ADDENDUM NO. 4

04/15/2026

YWCA OF GRAND ISLAND WYANDOTTE RENOVATION

315 WYANDOTTE ST

SHEET
A6.05

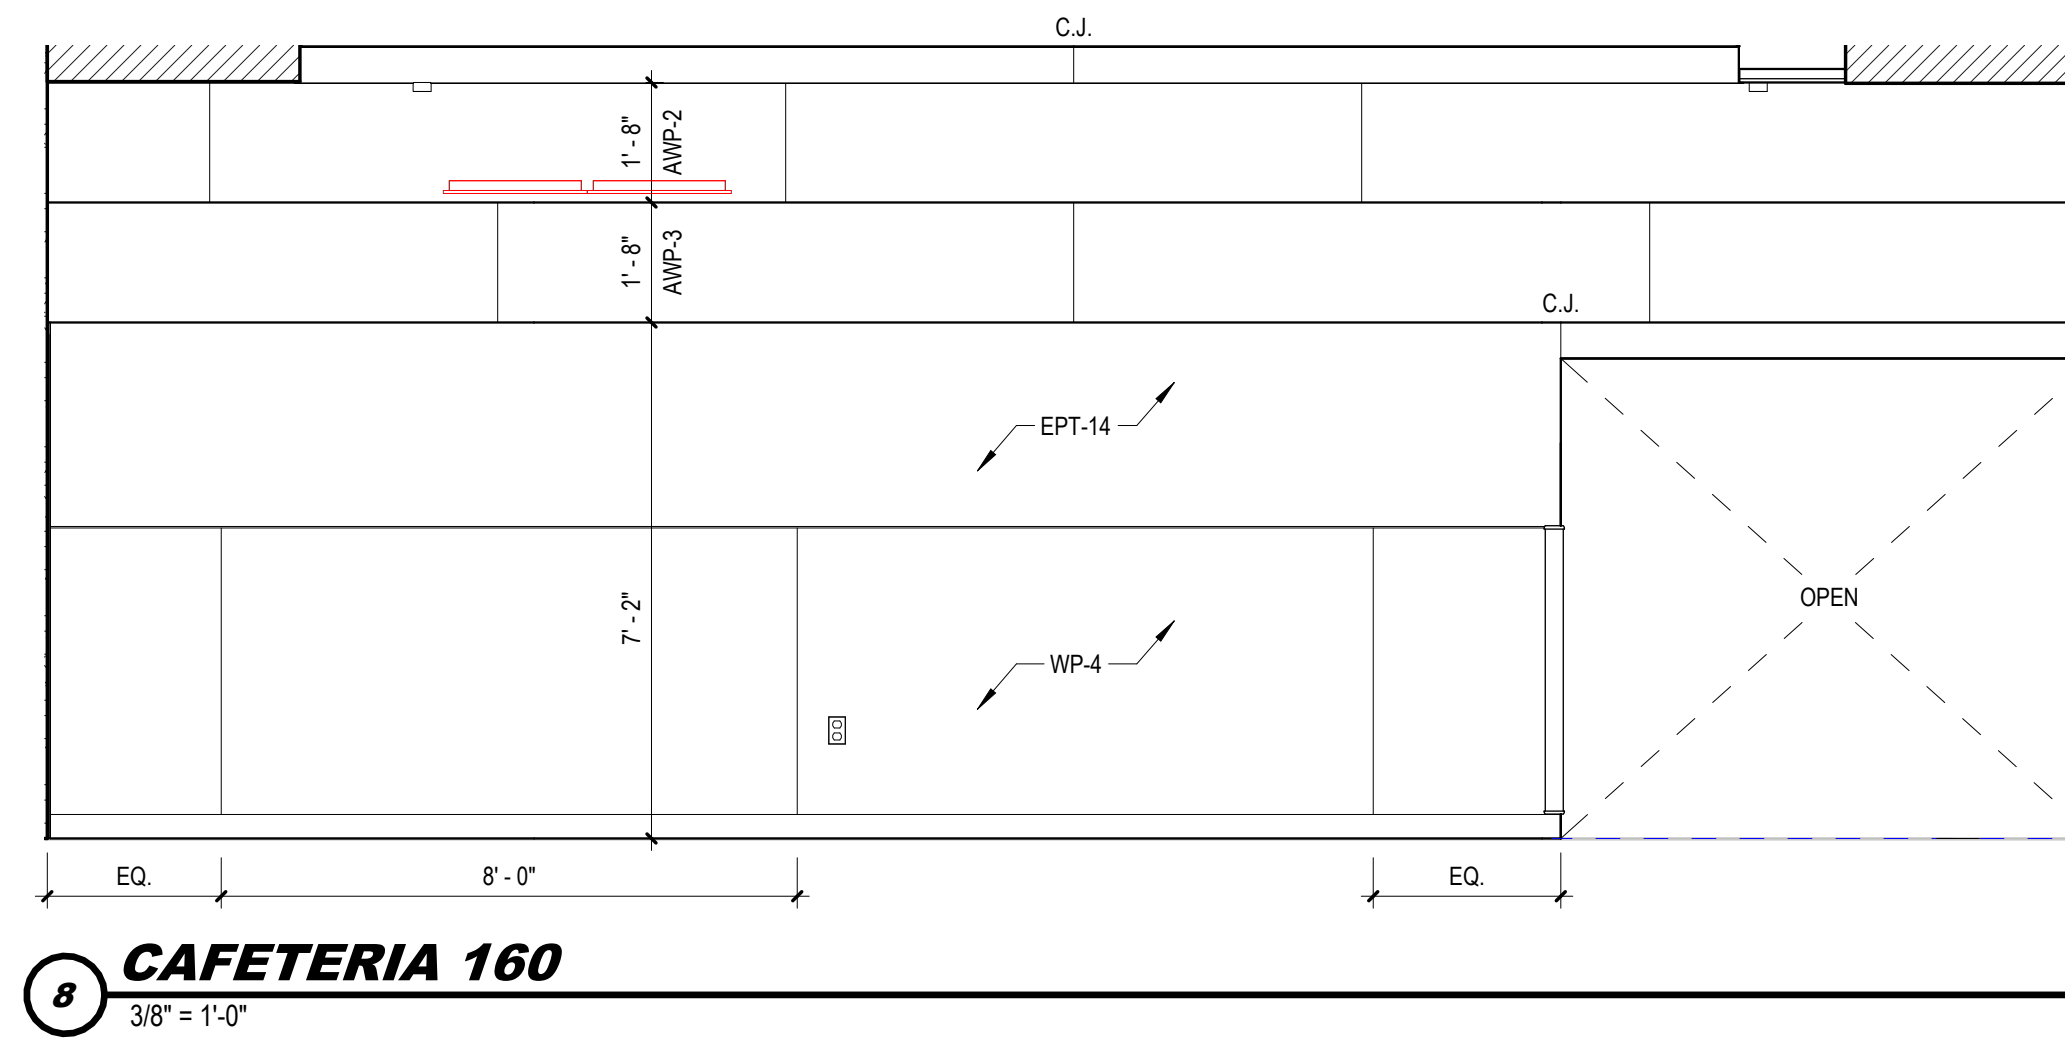
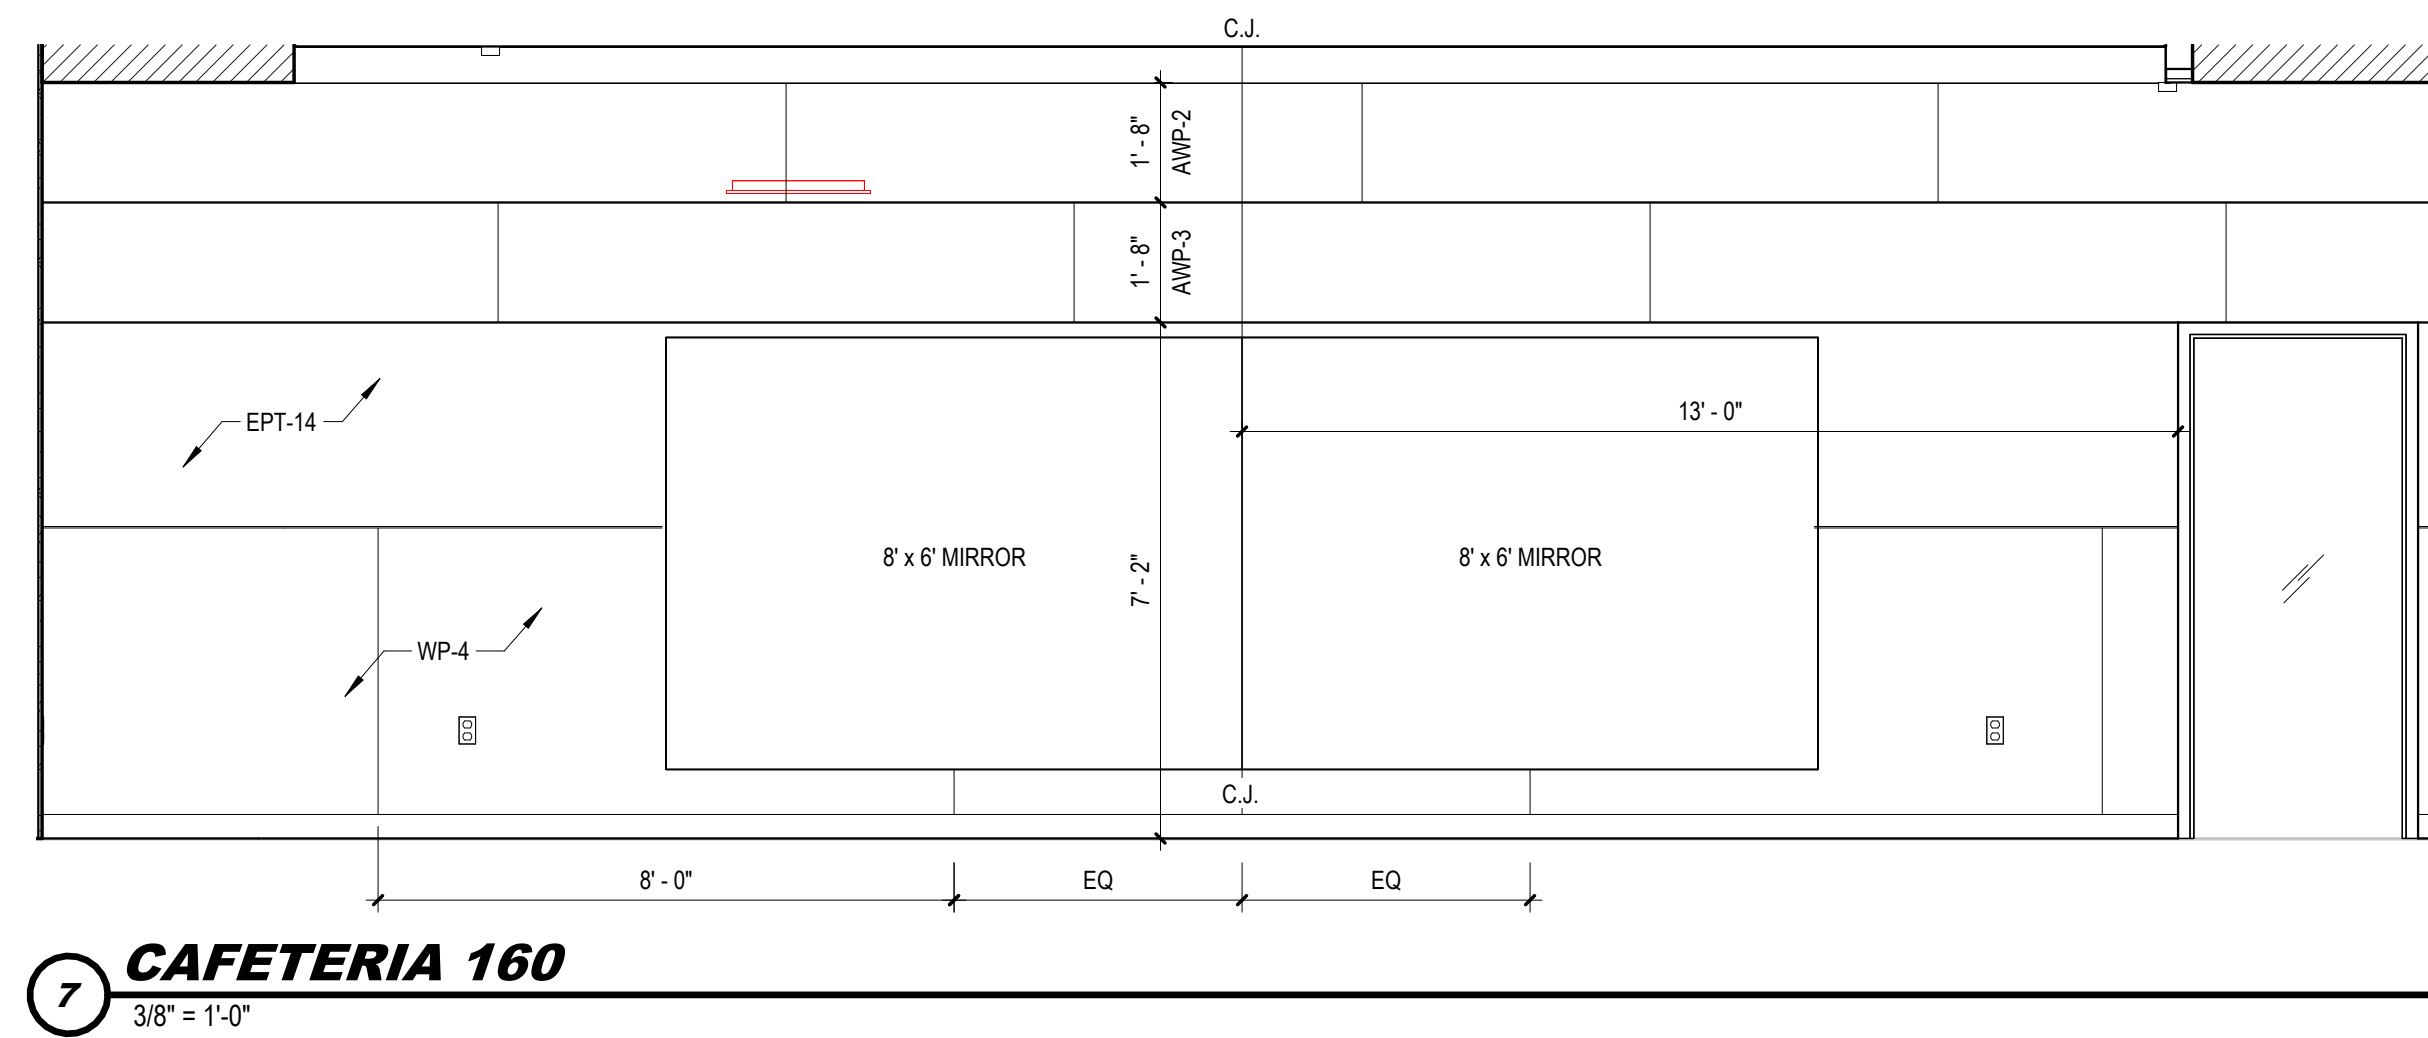
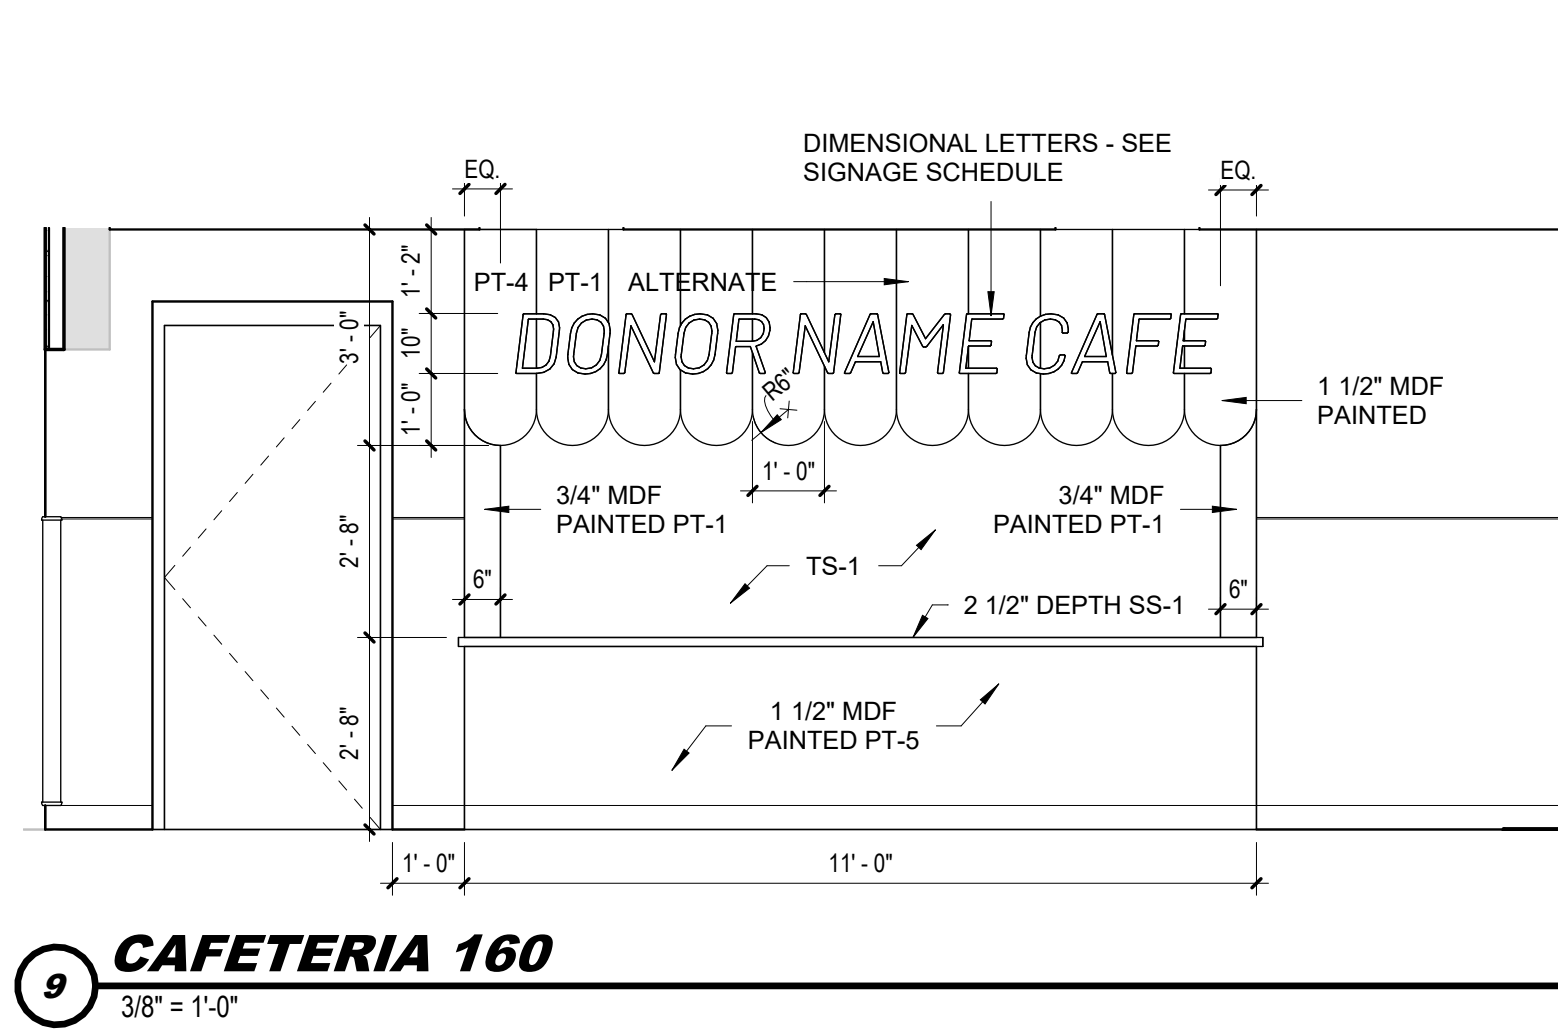
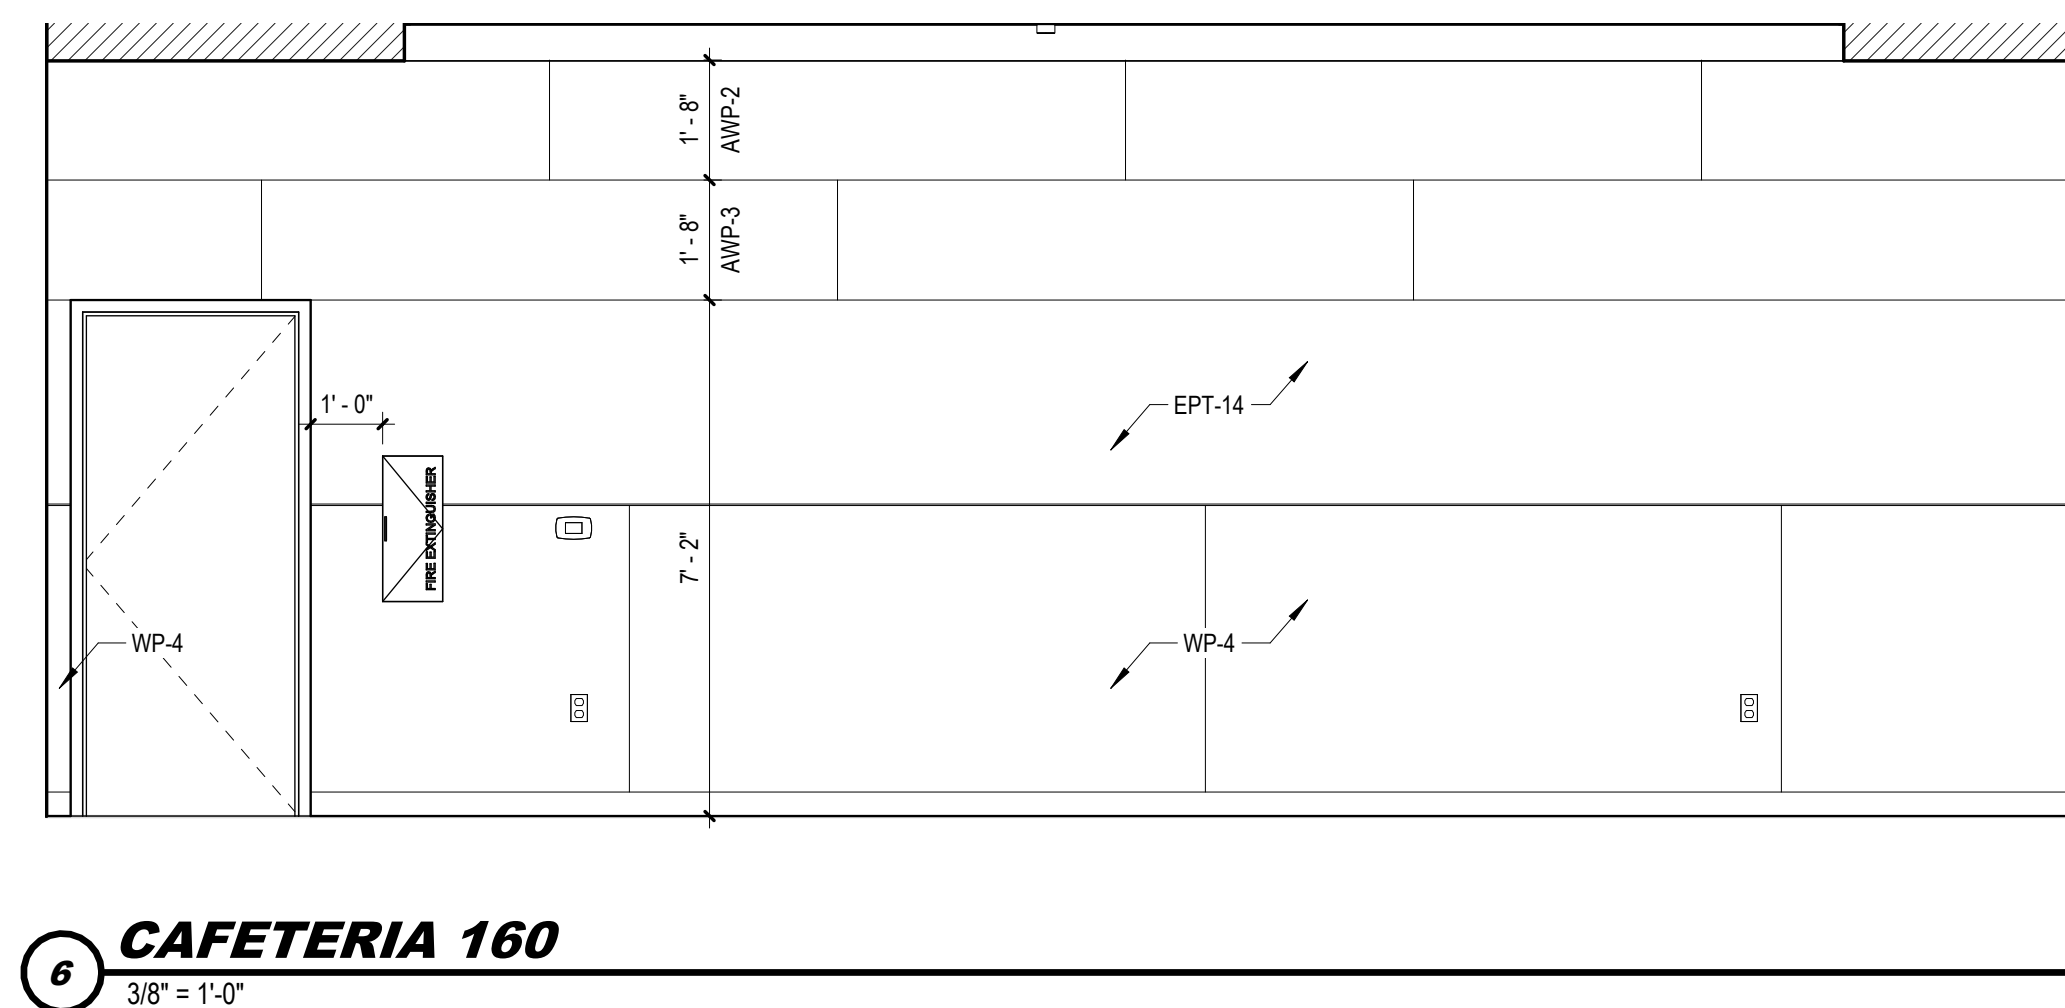
SHEET A6.05 - INTERIOR ELEVATIONS - CHILDCARE
